ADDENDUM No. 2

SWEET MARSH WILDLIFE MANAGEMENT AREA
BOAT CHANNEL DREDGING
BREMER COUNTY, IOWA
PROJECT NUMBER: 19-03-09-06

May 11, 2023

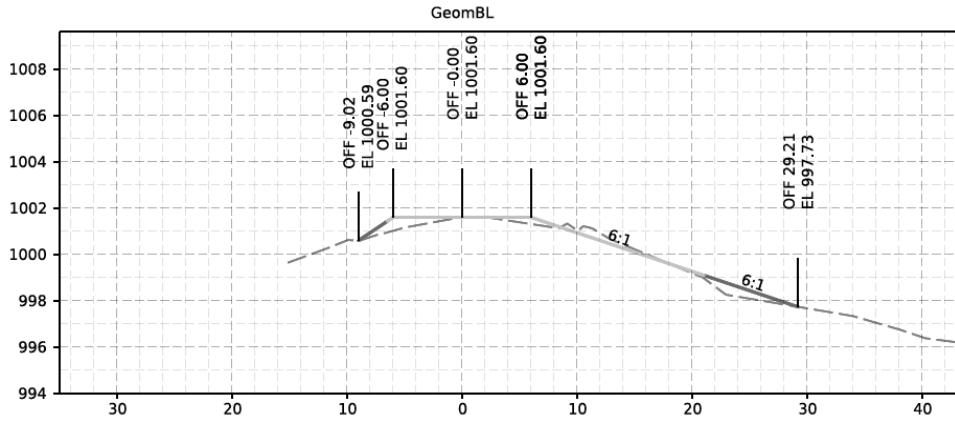
Can surface profile be provided? Mandi will provide CADD files. Design survey for the channels was completed from the lake's surface prior to draining.

A few sample cross sections of the dike repair grading are shown below.

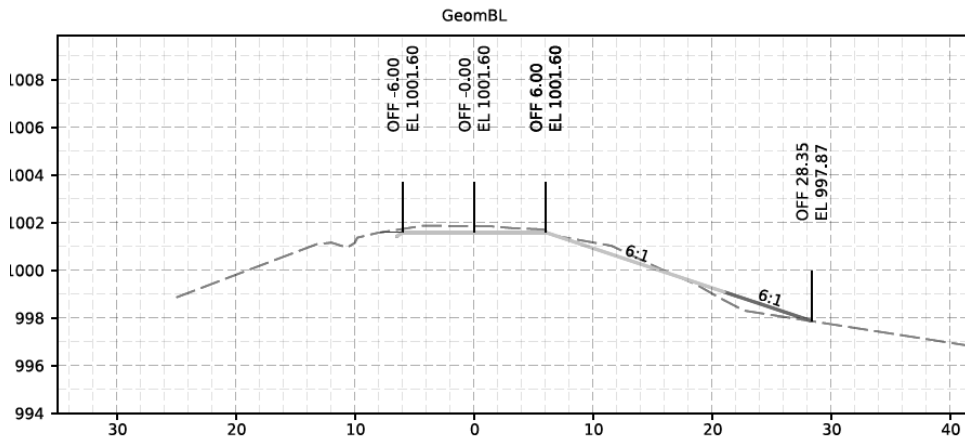
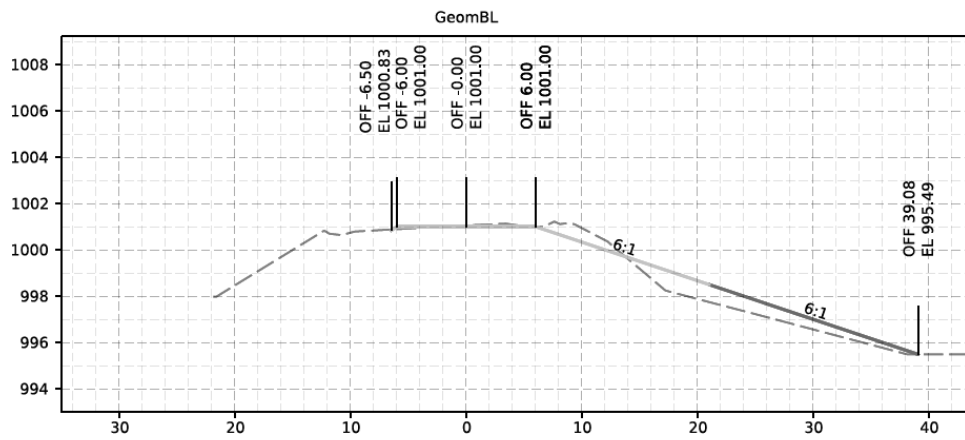
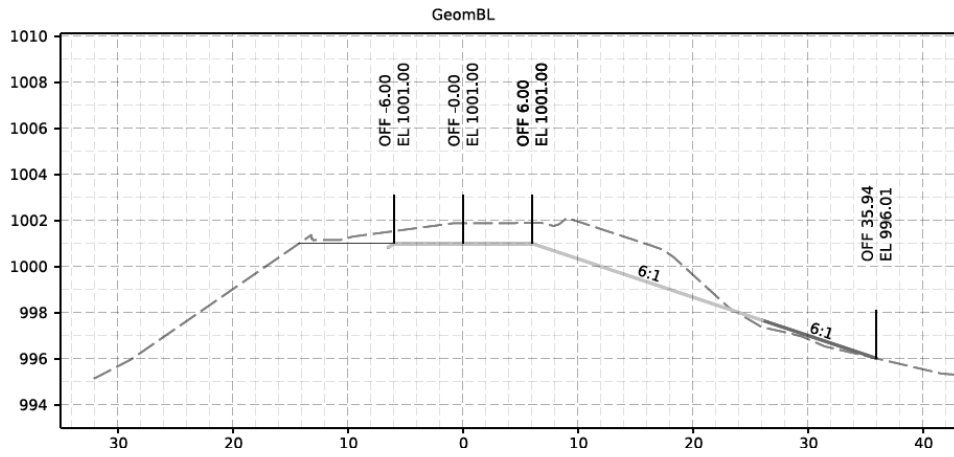
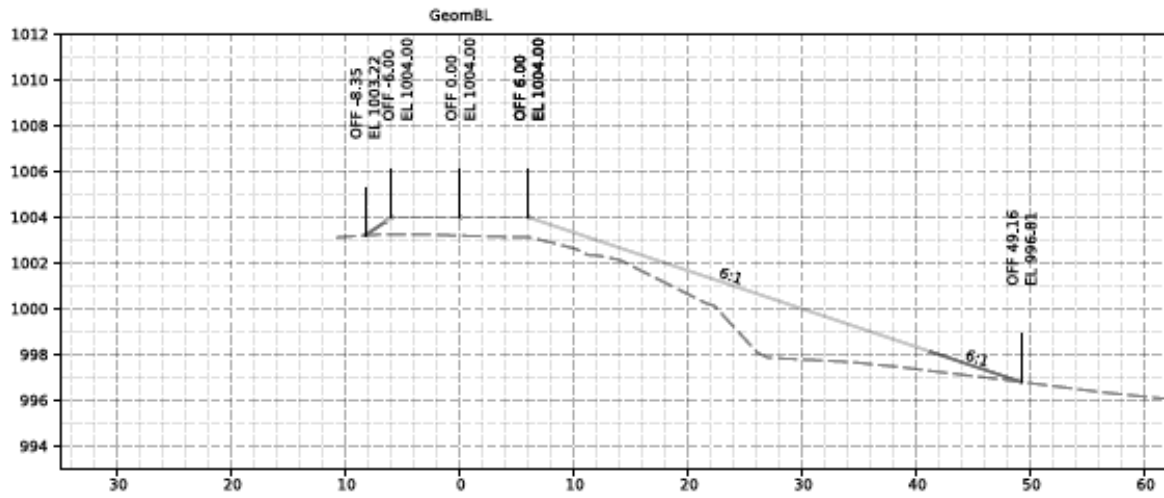
Is excavated dirt placed the entire length on the top of dike? There will be grading along the entire top of the dike. The amount of fill varies in depth. See E sheets for the top of dike profile and sample cross sections below.

Can the top of the dike width be greater than 12' after completion? The intent is to reconstruct the original dike cross section with a top width of 12'. Additional clarification: However, in some locations it will be necessary for the top to be wider in order to tie into the existing surface. See sample cross sections below.

Is 6000 CY for 6:1 slope enough? Yes. Some areas will have cut on the top and interior slope. See sample cross sections below.
